TRAILS AT ASPEN RIDGE FILING NO.2

EL PASO COUNTY, CO

ROADWAY & STORM IMPROVEMENT PLANS

FEBRUARY, 2020

BIRD RIDGE DRIVE CL PROFILE

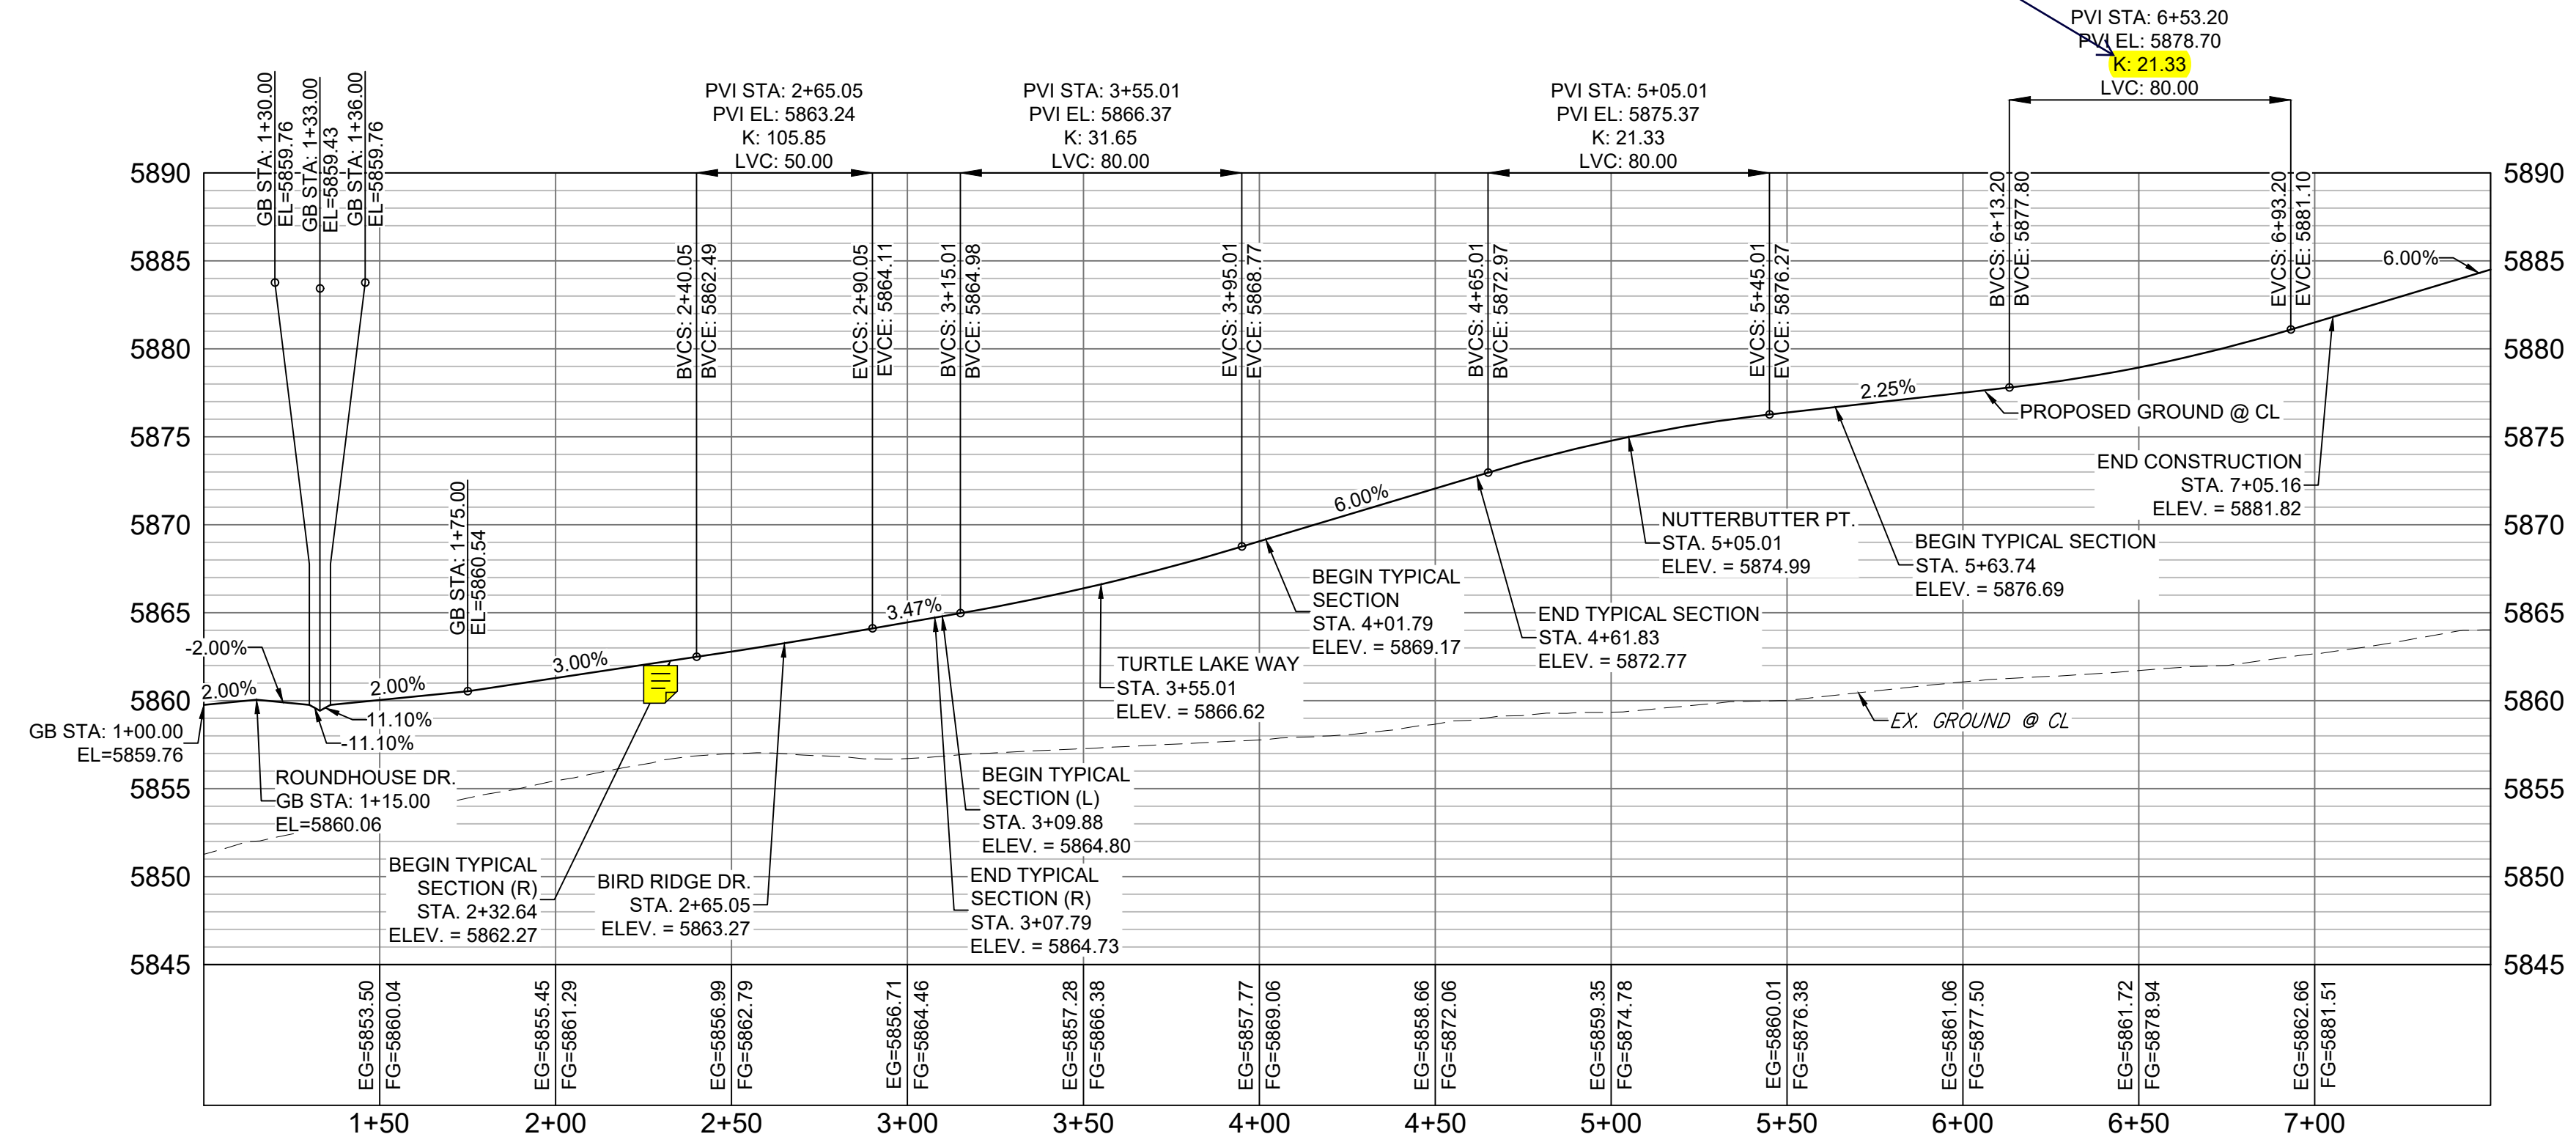
Update K value to meet criteria.

DETAIL A
BIG JOHNSON DRIVE/ ROUNDHOUSE DRIVE
INTERSECTION DETAILS

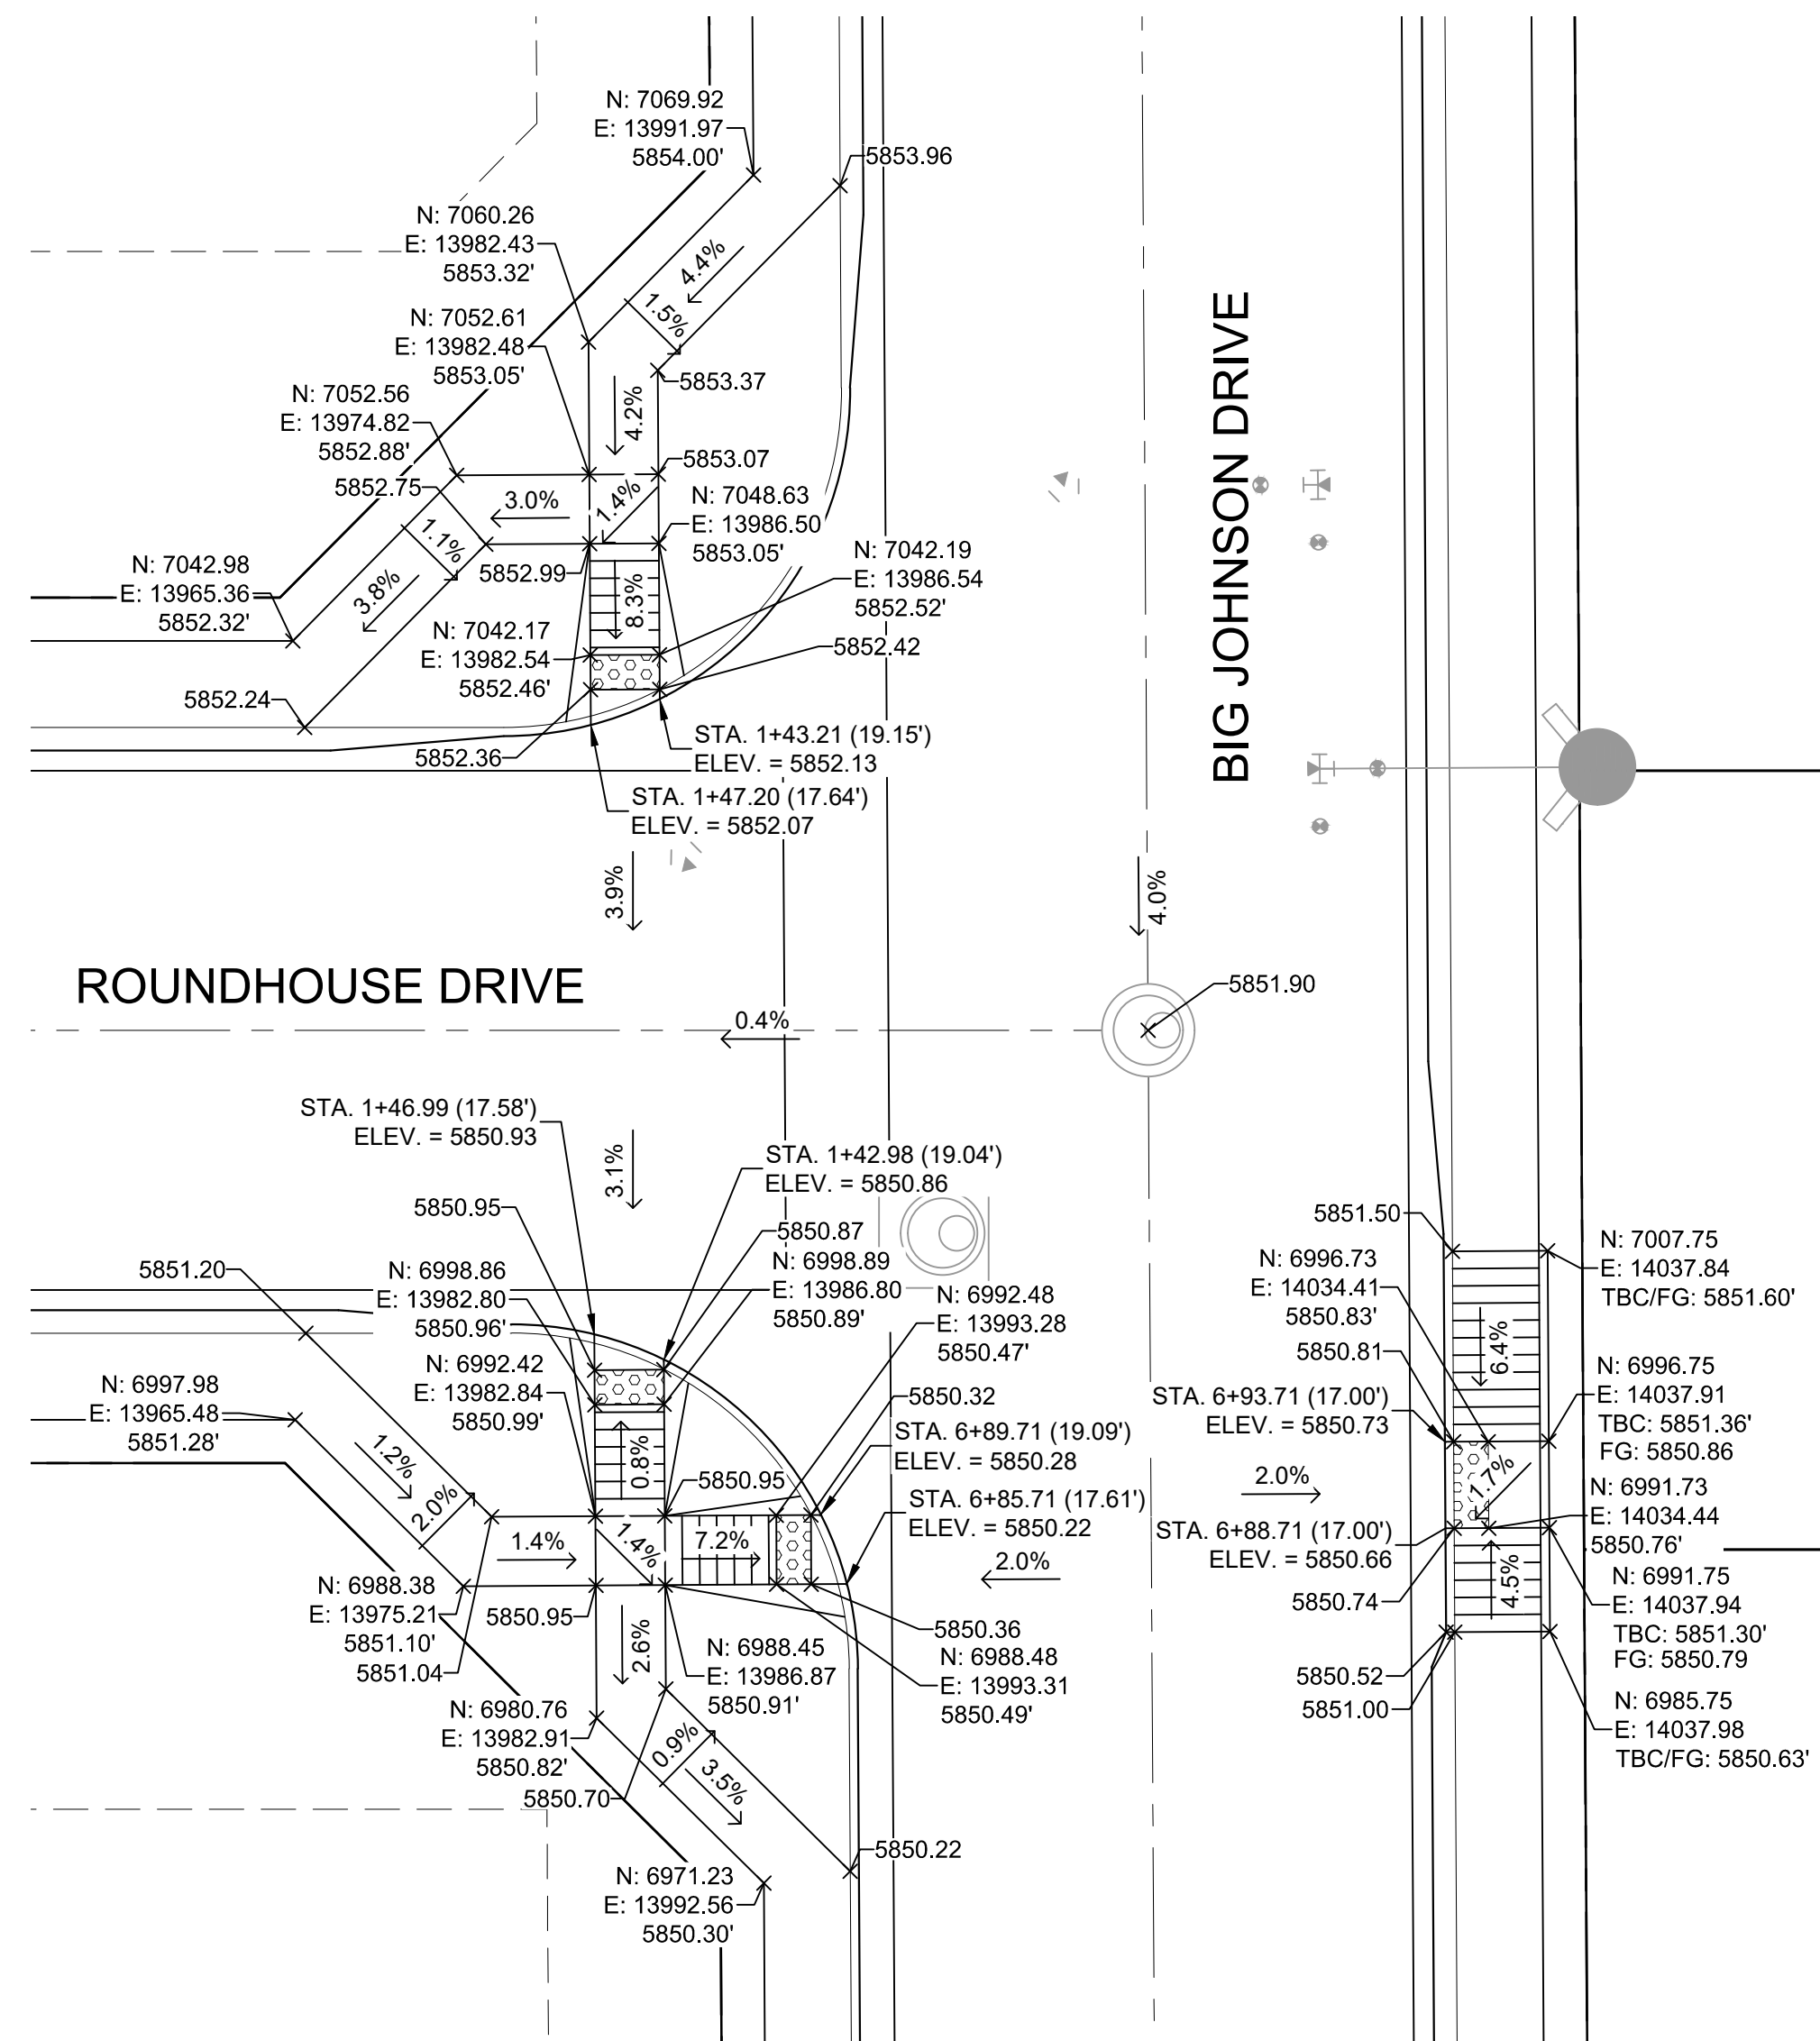
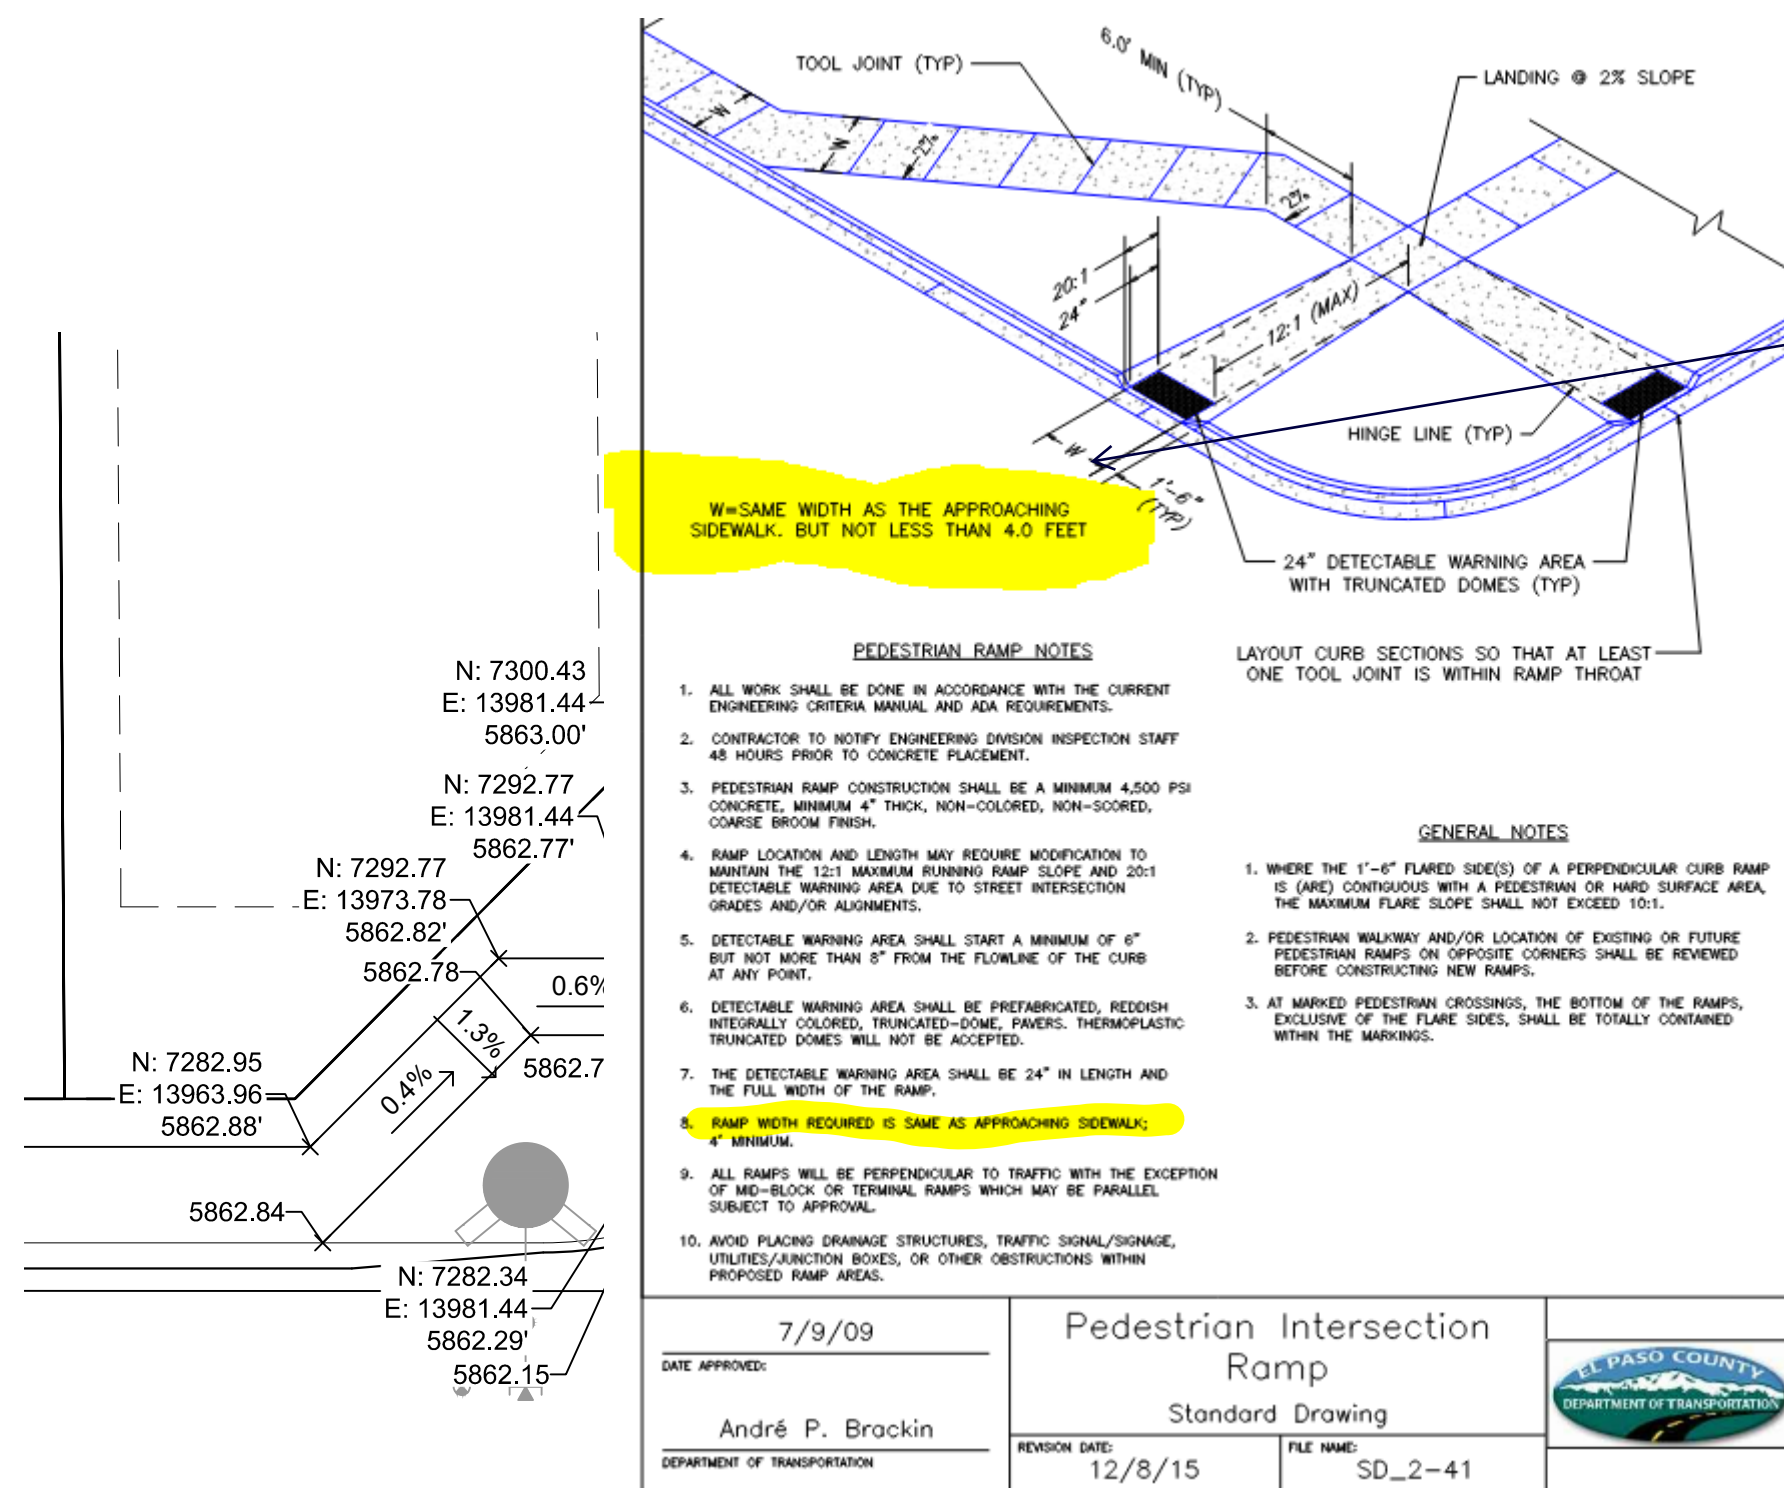
Per County detail SD_2-41 width at the truncated dome area shall be the same width as the sidewalk (5-ft)

Revise. Truncated dome width required to be full width of sidewalk per provided details. Unresolved.
